TITLE: Results of voting on CD xxxx-9 and Collation of Comments
Information Technology
Small Computer System Interface SCSI-3 Part 9: Parallel Interface (SPI)

SOURCE: SC 25 Secretary

PROJECT: 25.13.11.05

Figure 4 - Nonshielded device connector

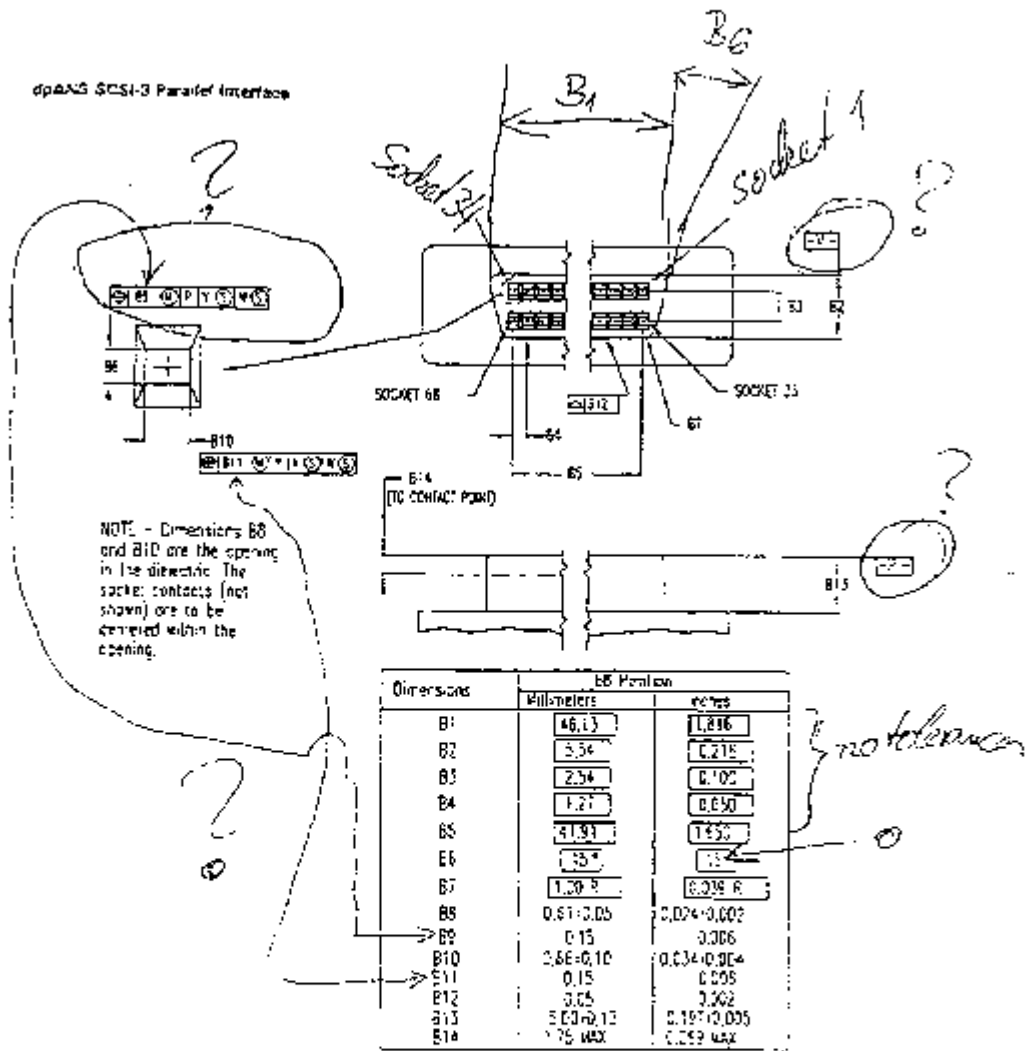
DE 12 figures 4 to 7: several items need to be clarified/amended, see handwritten comments on attached copies (4 pages).
